MIL-PRF-6106/19F
AMENDMENT 1
5 March 2001

PERFORMANCE SPECIFICATION SHEET

RELAYS, ELECTROMAGNETIC, PERMANENT MAGNET DRIVE,
25 AMPERES, SPDT, HERMETICALLY SEALED

This amendment forms a part of MIL-PRF-6106/19F, dated 10 November 2000, and is approved for use by all Departments and Agencies of the Department of Defense.

FIGURE 1. Relay, outline drawing.

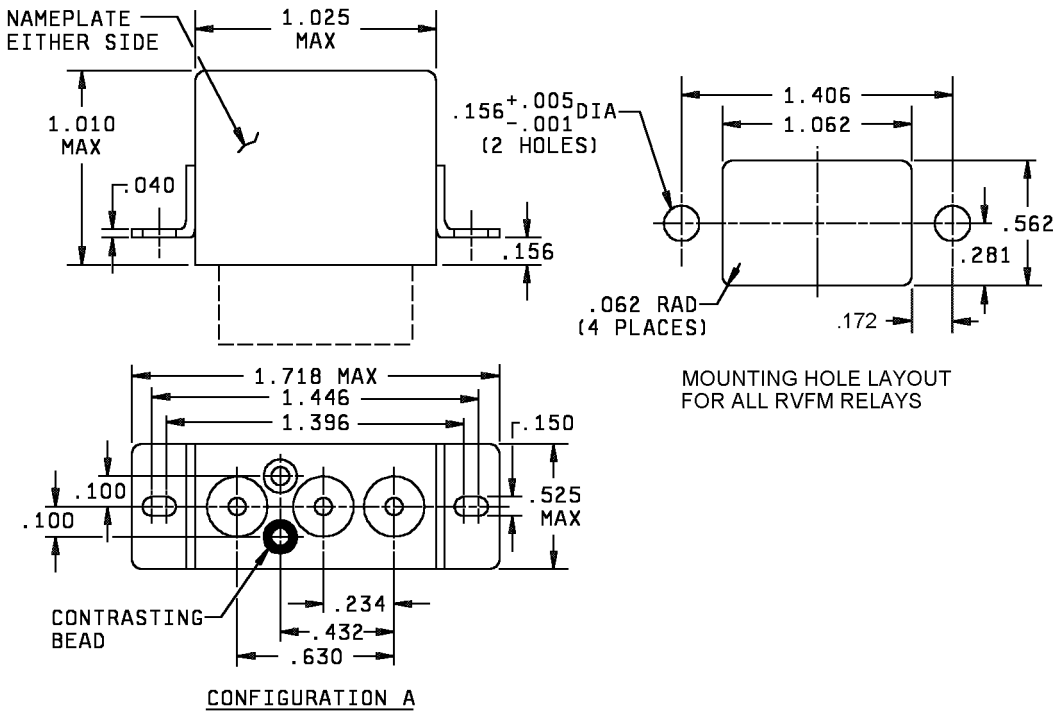
FIGURE 1: delete and substitute the following to correctly show the .172 dimension for the mounting hole layout and to change the description from "solder pin relays" to "RVFM relays".
